## Agenda Item # 2 - HOLDOVER SUB-002792-2023 & MOD-002804-2024

3201 Airport Boulevard, 410 & 450 Bel Air Boulevard

Resubdivision of Lot 1 of the Resubdivision of Lot 2 of  
Bel Air Mall Subdivision

- Subdivision approval to create two (2) legal lots of record from one (1) legal lot of record.
- Modification of a previously approved Planned Unit Development.

# SITE PLAN

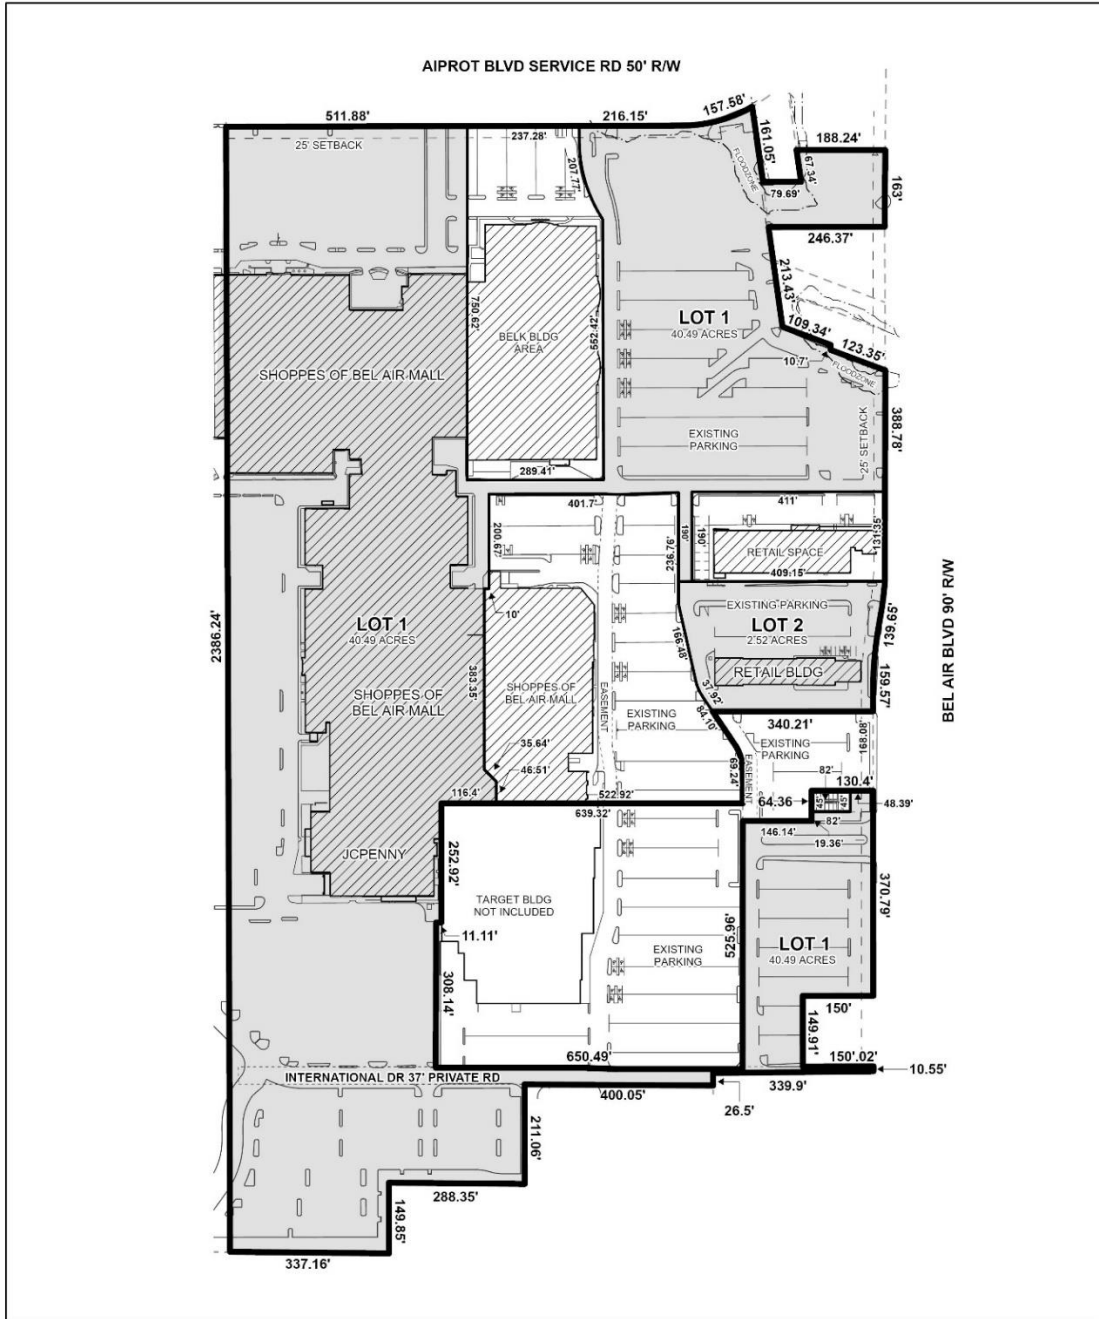
It should be noted that the PUD site plan correctly labels existing lots adjacent to the subject site, but does not clearly indicate that they are not a part of the subject Subdivision application. If approved, the Final Plat should be revised to clearly label adjacent lots and their associated Subdivision names as well as the associated map book and page or instrument number.

Additionally, the 2021 PUD included Lots 2 and 3, Resubdivision of Lot 2, Bel Air Mall Subdivision, and a condition of approval for that PUD was "inclusion of Lots 3 and 4, Bel Air Mall Subdivision". As submitted, the site plan states that only Lot 1, Resubdivision of Lot 2, Bel Air Mall Subdivision is included. As such, the application should be heldover so that the applicant can revise the site plan to include the required parcels highlighted in red on the images on pages 2 and 10 in this report. The inclusion of these additional parcels will not result in any additional notifications being required. However, the consent of the owners of those parcels will be required.

- 1) Revision of the site plan to include Lots 3 and 4, Bel Air Mall Subdivision as required by the 2021 PUD
- 2) Submittal of authorization of the property owners for Lots 2 and 3, Resubdivision of Lot 2, Bel Air Mall Subdivision and Lots 3 and 4, Bel Air Mall Subdivision; and
- 3) Revision of the site plan to clearly label adjacent lots and their associated Subdivision names as well as map book and page or instrument number.

- 1. Revision of the site plan, including the legal description, to clearly depict all parcels included in the Modification of the PUD;
- 2. Provision of a note on the recorded site plan stating future development, redevelopment, or any changes to the use and/or scope of operations of an existing use of the site may require additional modification of the Planning Approval to be approved by the Planning Commission and City Council;

- 3. Revision of the site plan to clearly label adjacent lots and their associated Subdivision names as well as map book and page or instrument number;
